SEWAGE DISPOSAL SYSTEM

**HOWARD COUNTY**  
BUREAU OF ENVIRONMENTAL HEALTH  
461-9933

SUBDIVISION Buckskin Woods ROAD 4249 Buckskin Lake Drive LOT 29  
~~9249 Holly Quarter Rd~~

RE: Building Permit Application No. 53898  
Proposed Inground Swimming Pool  
4249 Buckskin Lake Drive

PLOT PLAN  
 LOT 29  
 BUCKSKIN WOODS  
 5th ELECTION DISTRICT  
 HOWARD COUNTY, MARYLAND  
 SCALE 1"=100' DATE 12JUNE87  
 REVISED 11-27-87

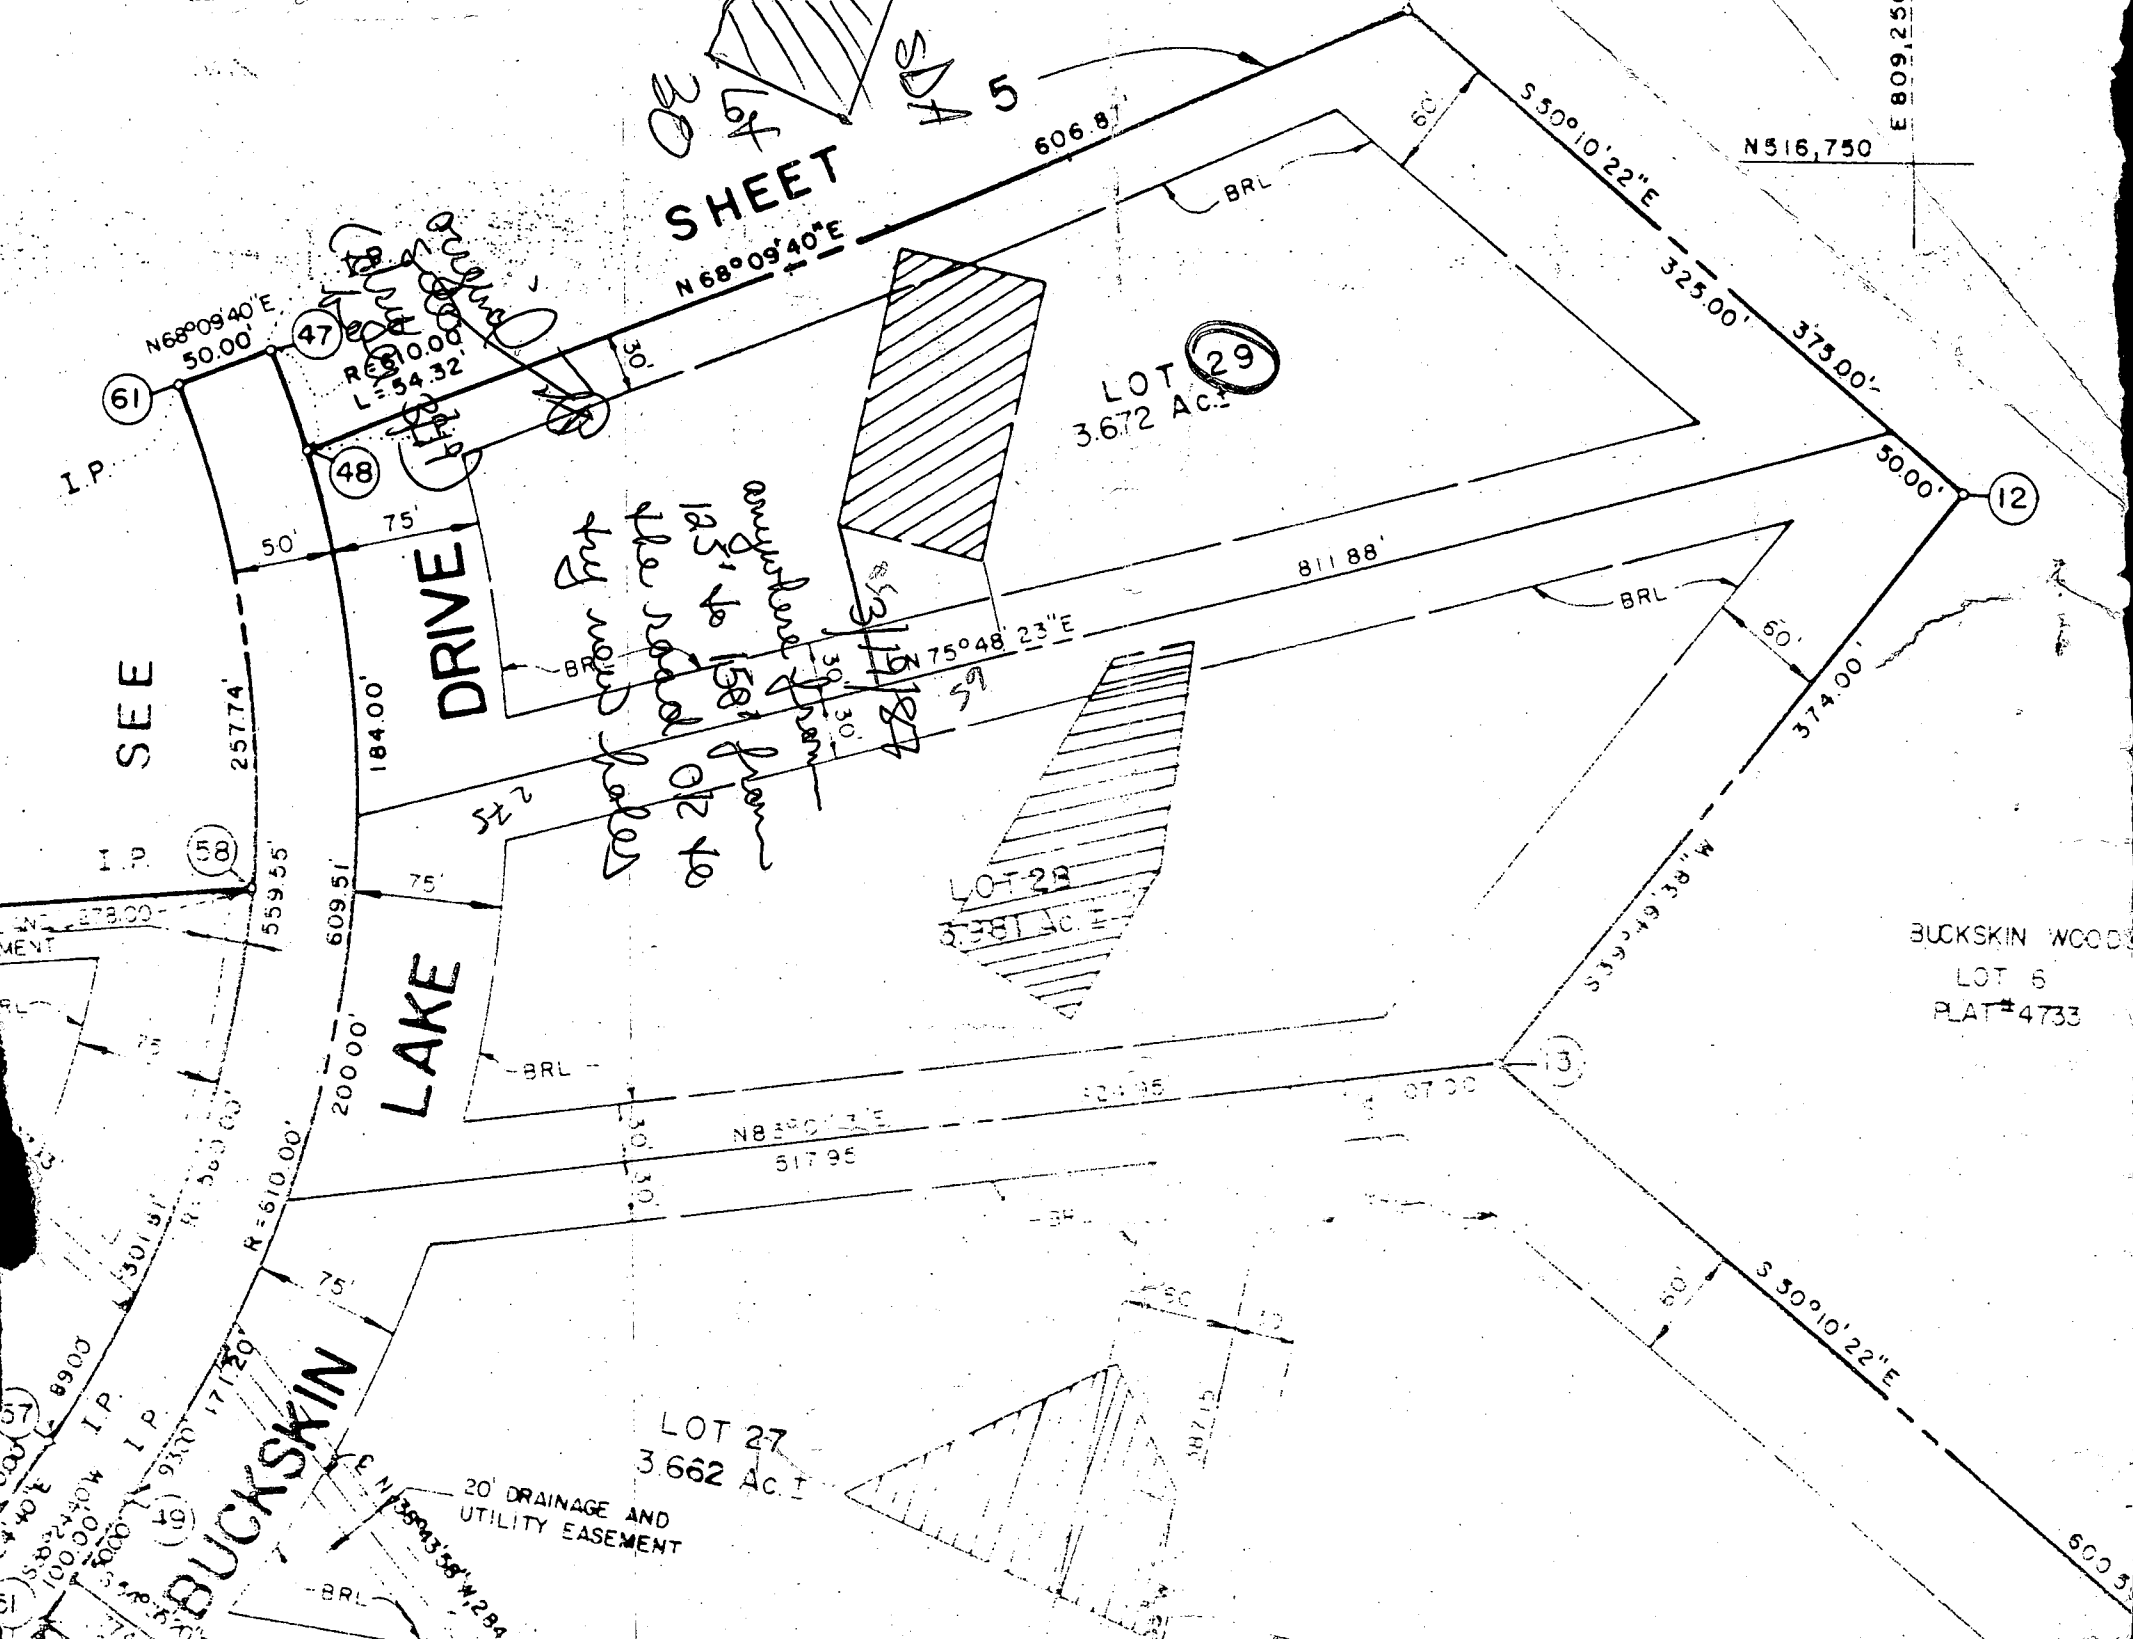
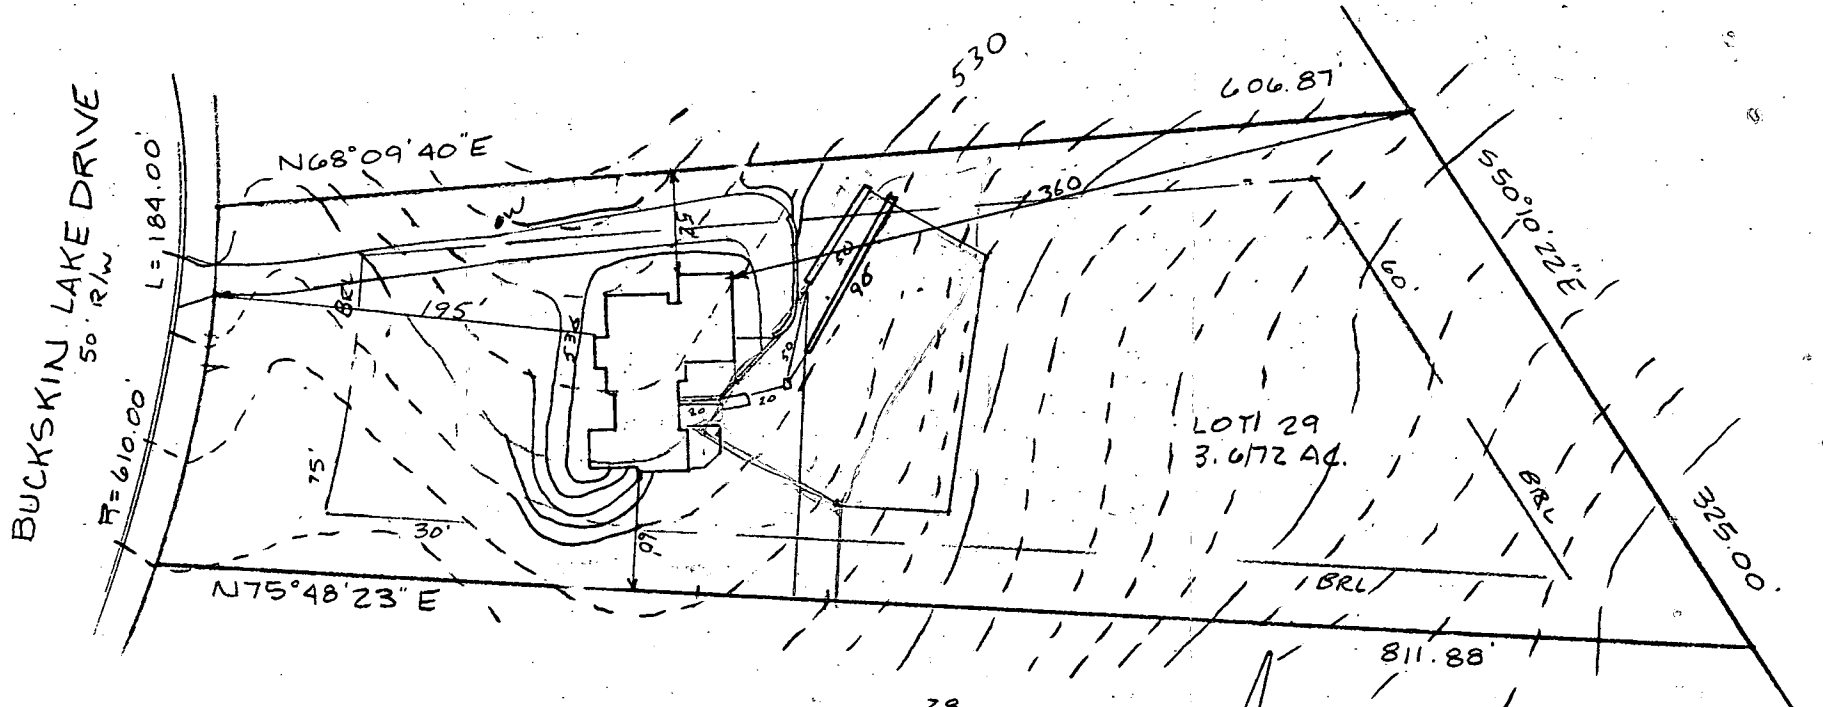
OK FOR 4BR  
 + DISPOSAL

12/15/87  
 ELEVATIONS OK  
 SHU

PLOT PLAN  
 LOT 29  
 BUCKSKIN WOODS  
 5th ELECTION DISTRICT  
 HOWARD COUNTY, MARYLAND  
 SCALE 1"=100' DATE 12JUNE87  
 REVISED 11-27-87

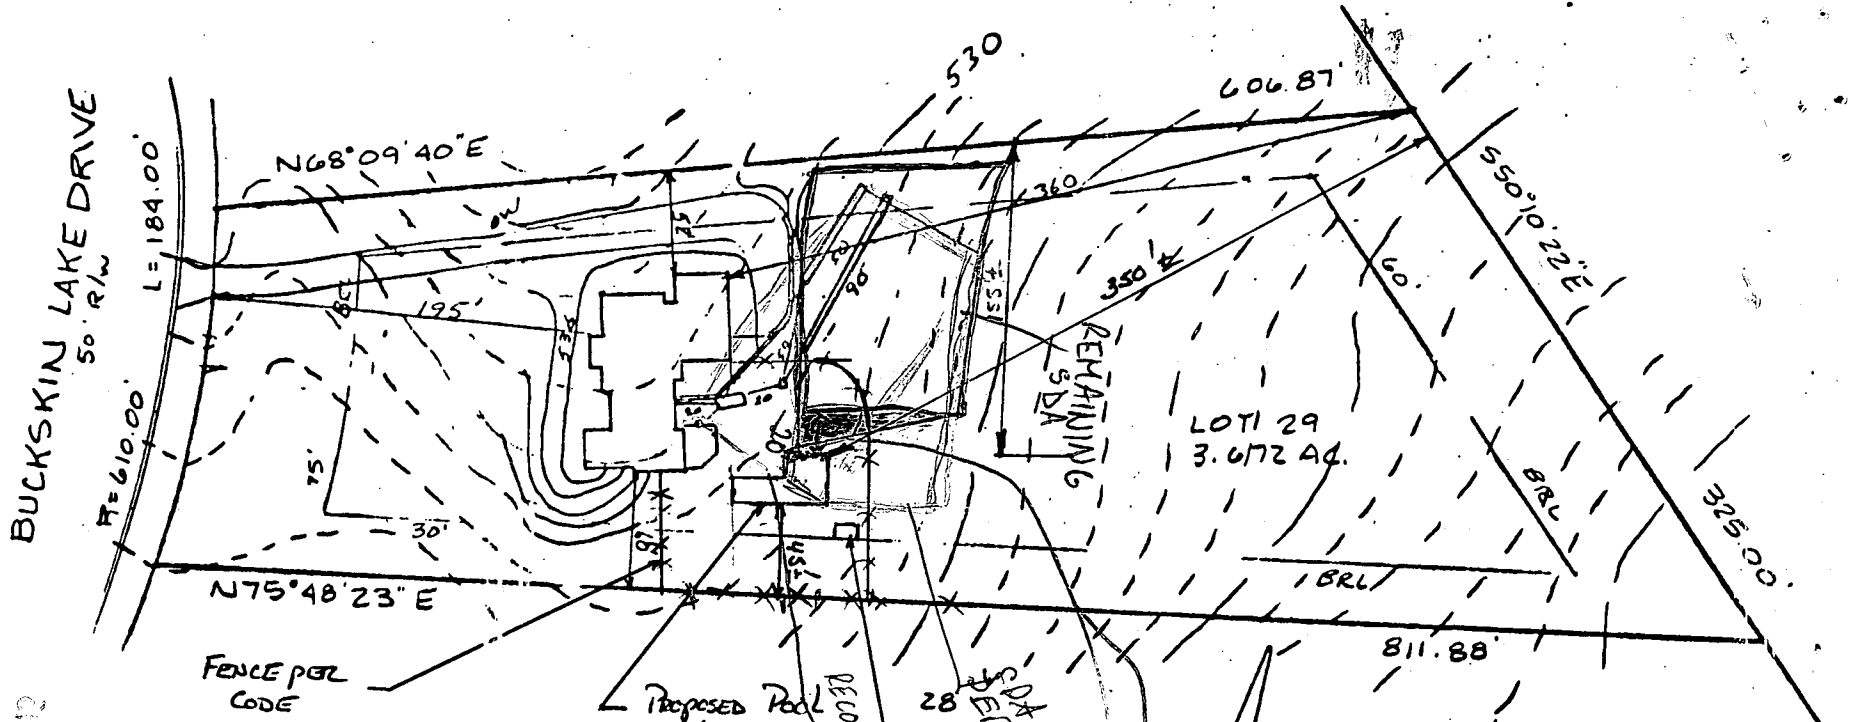
RECORDED  
 SEPTIC TANK  
 POOL STAKED  
 MR. 5/13/94  
 REMAINS OK TO  
 REMAINS SIGN  
 AREA ELIMINATED  
 BY CU 5/19/87  
 SHADDED  
 OR-108P  
 SDT AS  
 SHOWN APPROVED  
 BY CU 5/19/87  
 SDT AS  
 APPROVED  
 THIS DATE  
 NO APPROVAL  
 INTO ALREADY-COMPLETED  
 PROPOSED POOL INCLUDES  
 SEWAGE AREA

This office has received the above referenced building permit application, but cannot recommend approval at this time. The proposed pool location intrudes into the recorded sewage disposal easement, which has already been compromised by the house location.

A minimum of 10,000 square feet of declared sewage easement must be maintained on this lot. Encroachments into the sewage easement may only be permitted if they are approved by this office. Encroachments may be approved simply by a paper procedure, or via excavation of percolation test holes. In this case, a simple sewage easement revision on paper may be most appropriate.

RESOLVED  
5/13/94
